UNITED STATES PATENT AND TRADEMARK OFFICE

APPLICATION NO.	FILING DATE	FIRST NAMED INVENTOR	ATTORNEY DOCKET NO.	CONFIRMATION NO.
09/804,198	03/13/2001	Rikuro Obara	2523-061	9185

Office Action Summary

DETAILED ACTION

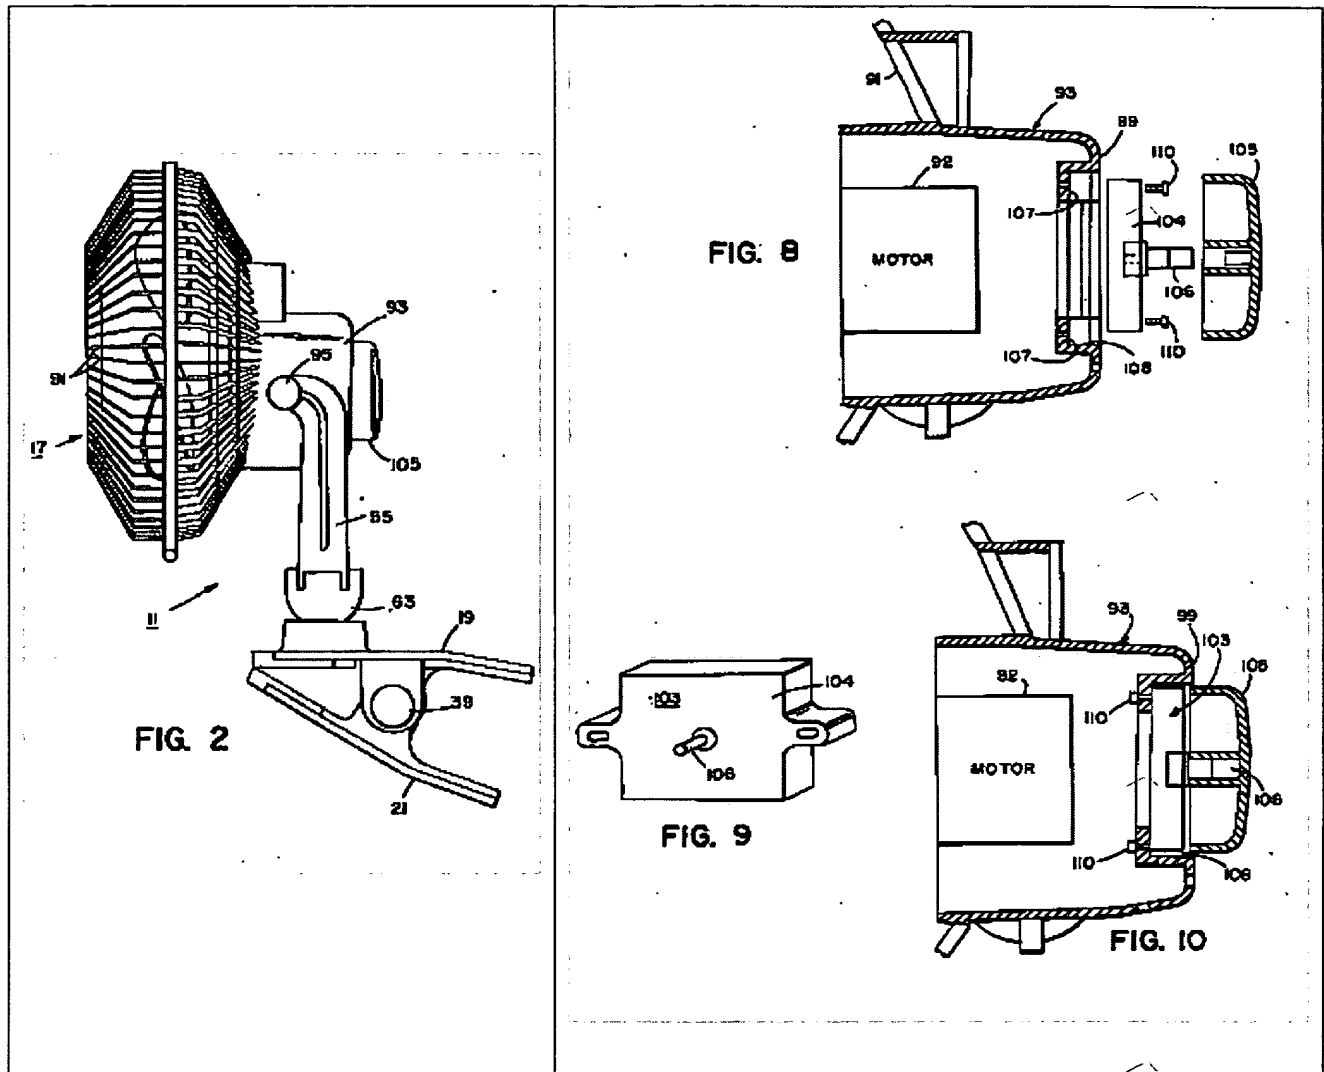
Shin-Chin, Figures 2 & 8-10 as displayed above disclose according to applicant's claims 1, 3, 6, 7 & 8, a blower (17) having an impeller (89) rotated by means of a motor (92), comprising: a base (93) for supporting the motor (92) in a frame (17), the base

JK
9/16/03 (93) provided at a central portion of the frame ¹⁷(93), a chamber {inside (93) and where (103) is located} with a front and back portions {(99), (105)} formed in the base (93), wherein the chamber is formed by the base (93) having a flange (99) extending to from the back portion from an outer periphery thereof forming a cylindrical body with a closed end for accommodating electrical components (103), and wherein the back portion of the chamber is at a downwind side and is occluded and sealed by a removable cover (105). See Shin-Chin, Figures 1-10 and respective portions, abstract, col. 4 lines 6-22 of the detailed description.

Shin-Chin, Figures 2 & 8-10 as displayed above disclose according to applicant's claims 1, 3, 6, 7 & 8, a blower (17) having an impeller (89) rotated by means of a motor (92), comprising: a base (93) for supporting the motor (92) in a frame (17), the base (93) provided at a central portion of the frame (17), the base (93) supported {concentrically} at the central portion of the frame by stays (91), a chamber {inside (93) and where (103) is located} with

a front and back portions {(99), (105)} formed in the base (93), wherein the chamber is formed by the base (93) having a flange (99) extending to from the back portion from an outer periphery thereof forming a cylindrical body with a closed end for accommodating electrical components (103), and wherein the back portion of the chamber is at a downwind side and is occluded and sealed by a removable cover (105). See Shin-Chin, Figures 1-10 and respective portions, abstract, col. 4 lines 6-22 of the detailed description.

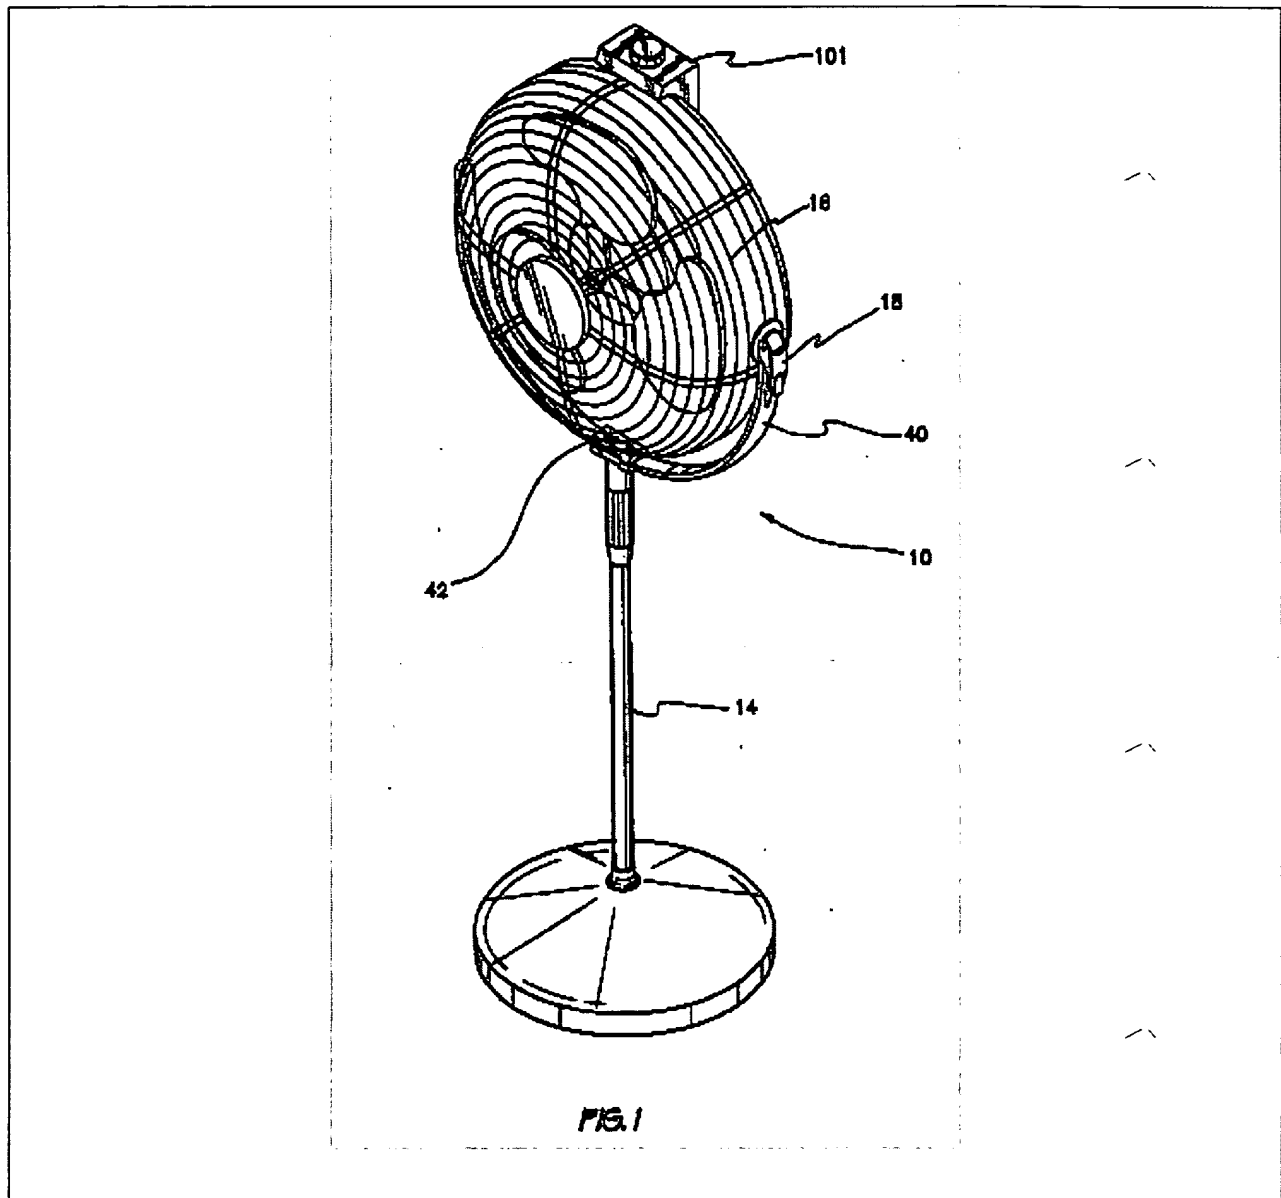
Wolfe et al., Figure 1 as immediately displayed above discloses a fan (10) where the motor base (2) is supported by stays (16) via u-

frame (40). See Wolfe et al., Figures 1 & 2 and respective portions, abstract, col. 2 lines 64-67 & col. 3 lines 1-18 of the detailed description.

It would have been obvious to an artisan of ordinary skill in the art at the time the invention was made to take the fan blower of Shin-Chin and modify it according to Wolfe et. al so as to support the fan in an alternative fashion for esthetic purposes.
